UNITED STATES PATENT AND TRADEMARK OFFICE

APPLICATION NO.	FILING DATE	FIRST NAMED INVENTOR	ATTORNEY DOCKET NO.	CONFIRMATION NO.
10/574,234	04/03/2007	Bror Eriksson	02544.002090	2155
5514	7590	03/21/2008	EXAMINER	
FITZPATRICK CELLA HARPER & SCINTO 30 ROCKEFELLER PLAZA NEW YORK, NY 10112			SELF, SHELLEY M	
ART UNIT		PAPER NUMBER		
3725				
MAIL DATE		DELIVERY MODE		
03/21/2008		PAPER

Office Action Summary	Application No.	Applicant(s)	
	10/574,234	ERIKSSON, BROR	
	Examiner	Art Unit	
	Shelley Self	3725

DETAILED ACTION

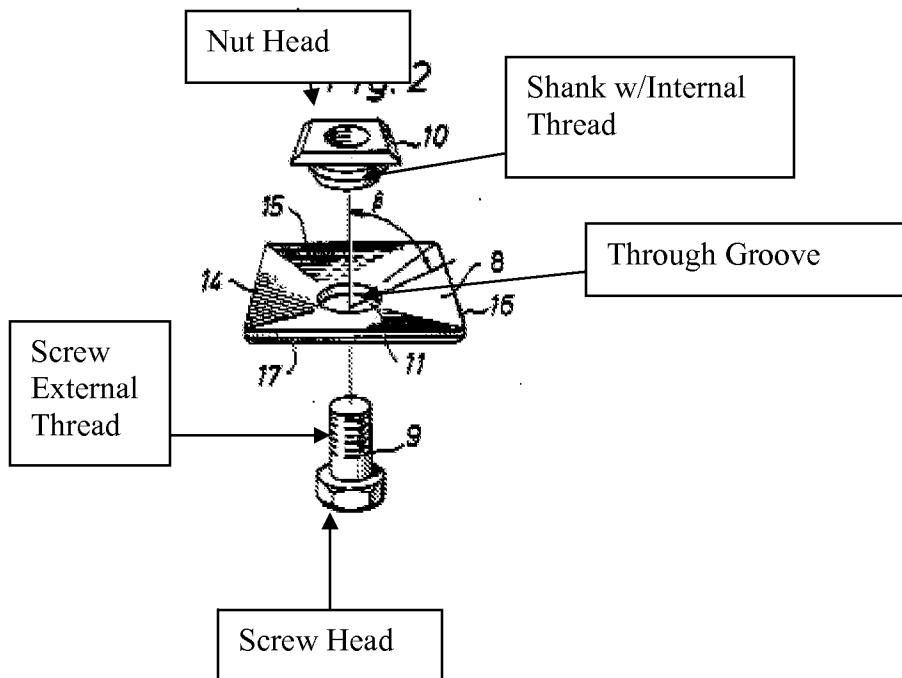
Claims 1-8 as best as can be understood are rejected under 35 U.S.C. 102(b) as being anticipated by Jonsson (4,231,046). With regard to claims 1 and 6, Jonsson discloses a barking device comprising a barking arm (fig. 1), a barking tool (8), which has at least one barking edge (fig. 3), which is mountable in a tool seat (fig. 3) at an outer end of the arm (fig. 1), the barking arm being pivotally connectible to a rotor, the barking tool comprising a convex mounting surface (fig. 3) to abut against a concave seat surface (12; fig. 3), connecting means mountable to the tool seat, characterized in that the connecting means comprises two connecting means parts, a first connecting means part in the form of a screw (9) with an externally threaded shank (fig. 2) and a head (fig. 2) and a second connecting means in the form a "sleeve-like nut" (10) with an internally threaded shank (fig. 1) into which the shank of the screw (9) is screwable and a head, the barking device further comprises a through hole (fig. 1-3) and through groove, a counter sink (fig. 2, 3) and mounting surface (fig. 23)

As to the recitation, “sleeve-like nut with internal threaded shank”, Examiner notes Jonsson, inherently disclose the sleeve (10) to be internally threaded so as to securing fasten the screw (9) to the device for securing the barking tool (fig. 3).

With regard to claim 2, Jonsson discloses wherein the length of the shank (fig. 2) of the nut (10) is adapted so that, when the nut is in the connecting position the nut extends at least a distance into the part.

With regard to claims 3 and 7, as best as can be understood, Jonsson discloses a keel shape.

With regard to claim 4, as best as can be understood, Jonsson discloses a groove shaped concave seat (fig. 3).

With regard to claims 5 and 8, as best as can be understood, Jonsson discloses a ridge extending essentially perpendicular to the intended direction of feeding of the logs (fig. 1-3)
